Bid #09-11-12-04 "Hawthorne Terrace Water System Improvements"

BID NO. 09-11-12-04
HAWTHORNE TERRACE WATER SYSTEM IMPROVEMENTS
CONTRACT NO. 3 - MODIFICATIONS TO WELL HOUSES
CITY OF DANBURY PROJECT NO. 03-17C

ADDENDUM NO. 1

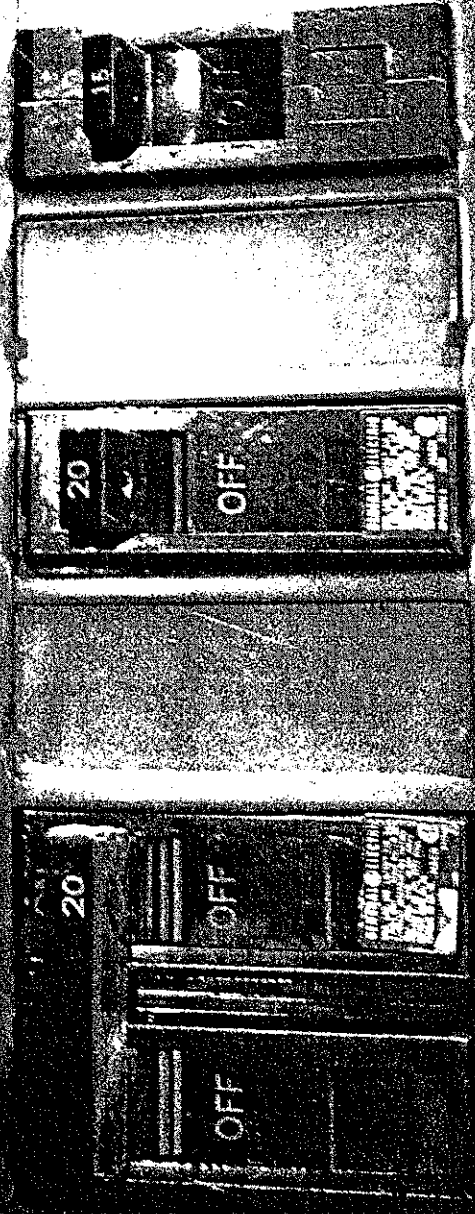
9. The Memorandum on the pre-bid Meeting, which also includes responses to Bidders' questions, is attached and made a part of this Addendum.
10. A photo of the lighting panel at the Upper Well House is attached and made a part of this Addendum.

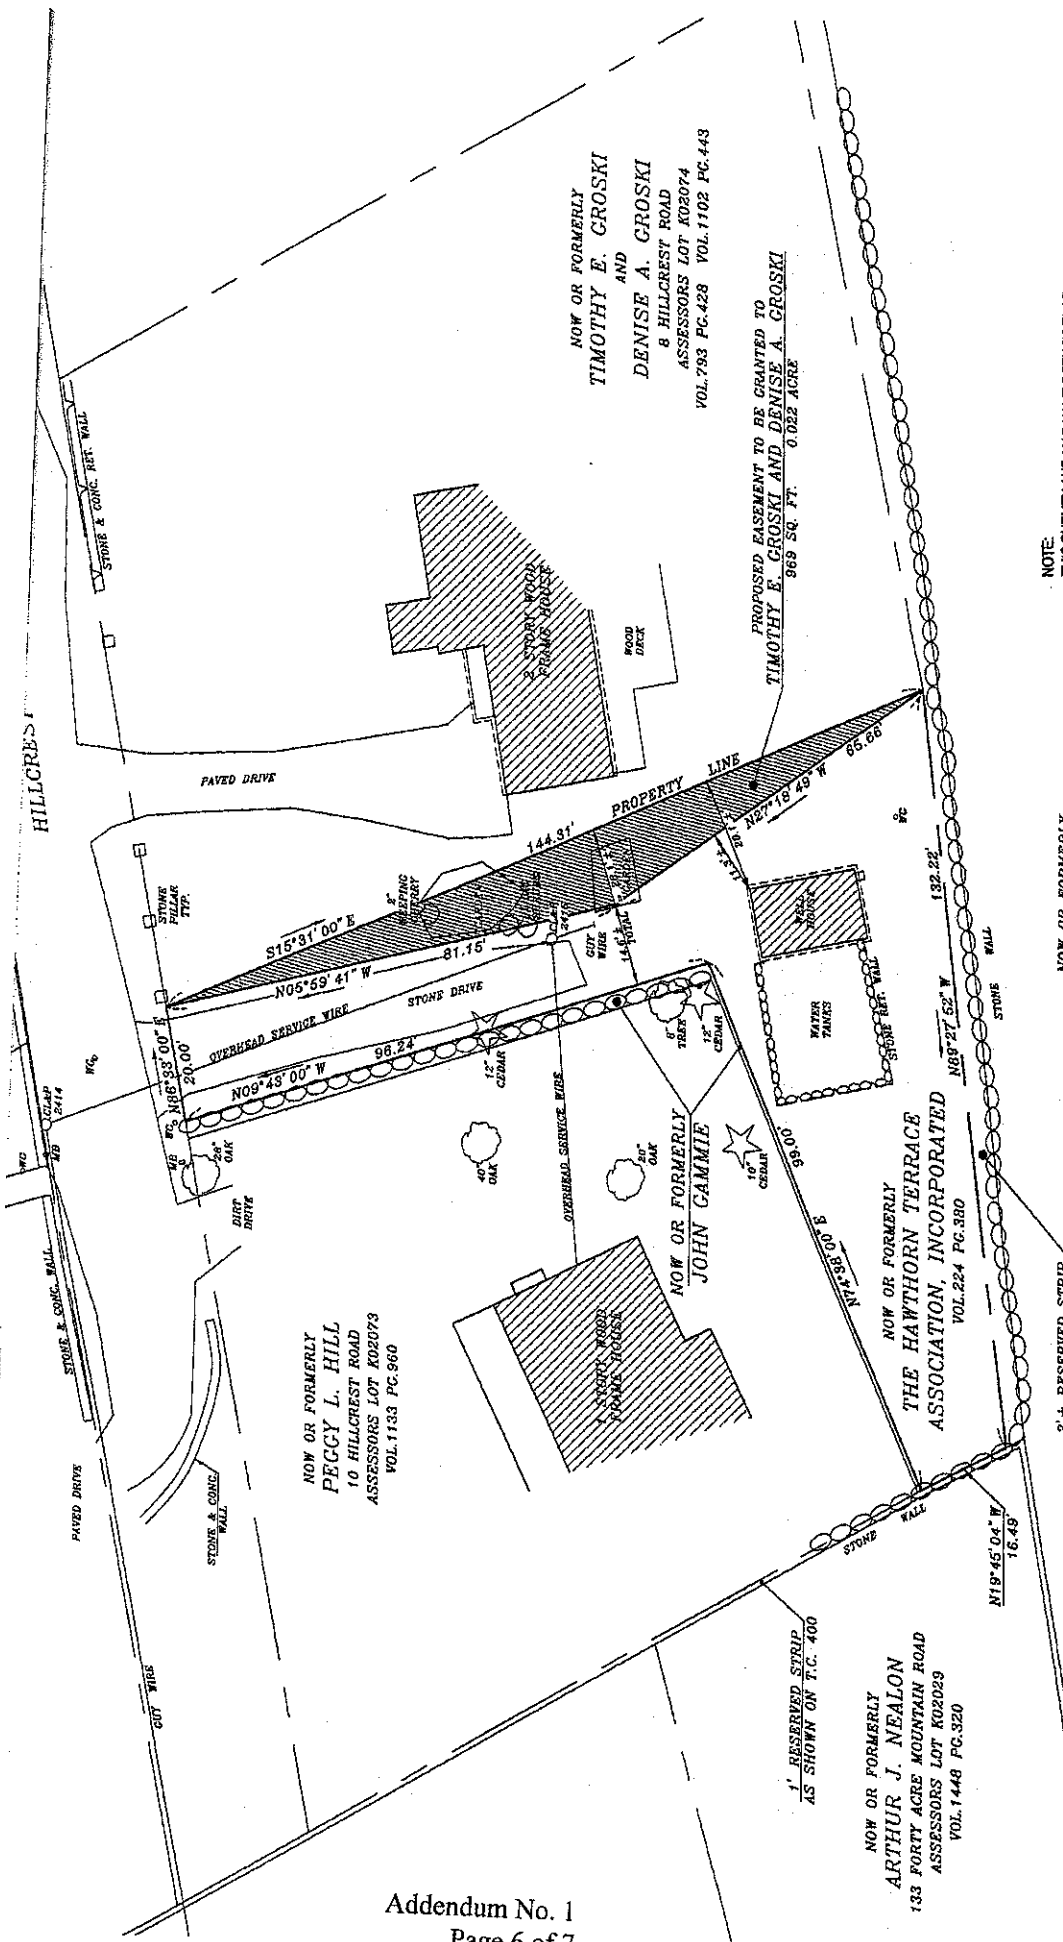
11. A sketch of the trees located by the City of Danbury at the Lower Well House is attached and made a part of this Addendum.
12. An excerpt of the map showing an easement granted to Timothy E. Groski and Denise A. Groski and the property at the Upper Well House is attached and made a part of this Addendum.

PROPOSED EASEMENT TO BE GRANTED TO
 TIMOTHY E. GROSKI AND DENISE A. GROSKI
 869 SQ. FT. 0.022 ACRE

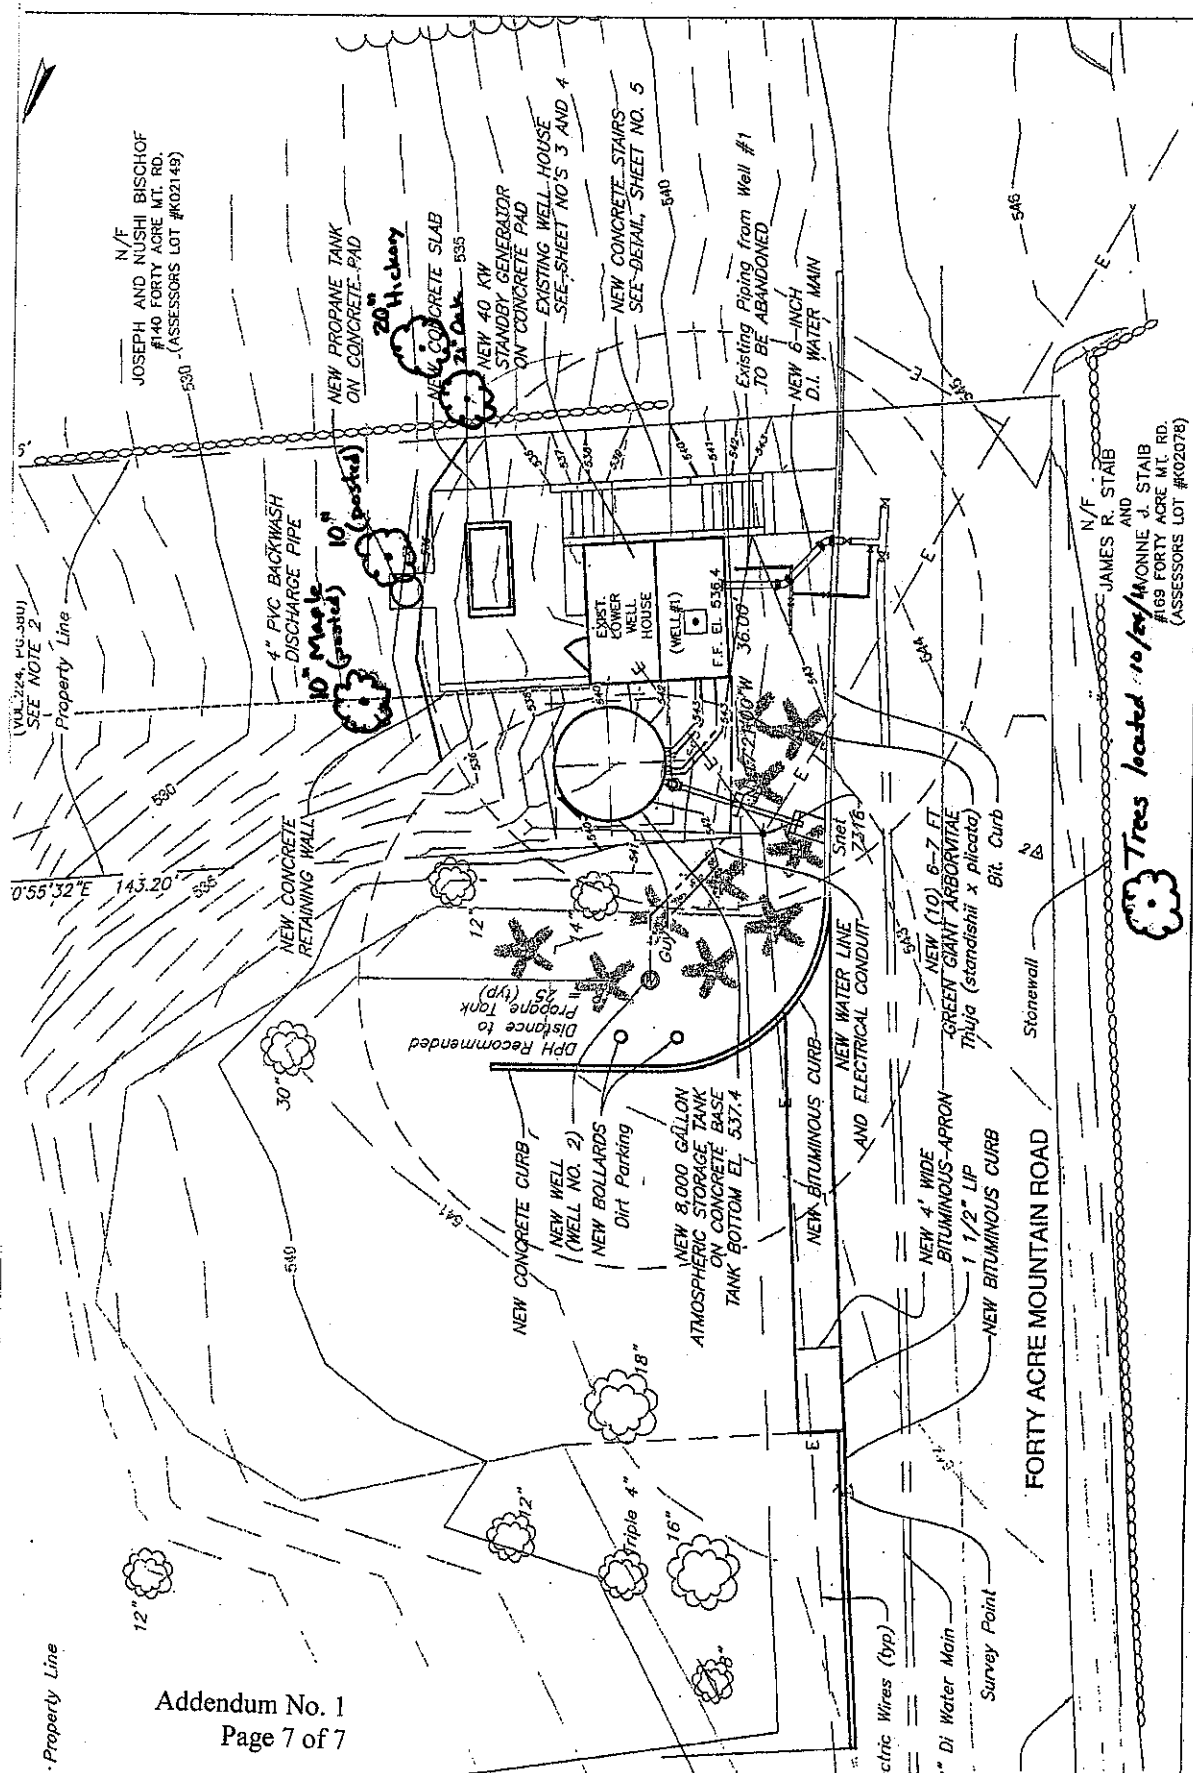
- What is the limit of land owned or to be owned by the City at the Upper Well House? *City, at a minimum, owns between the utility pole and the hedge row. A map of the property will be provided to the bidders.*
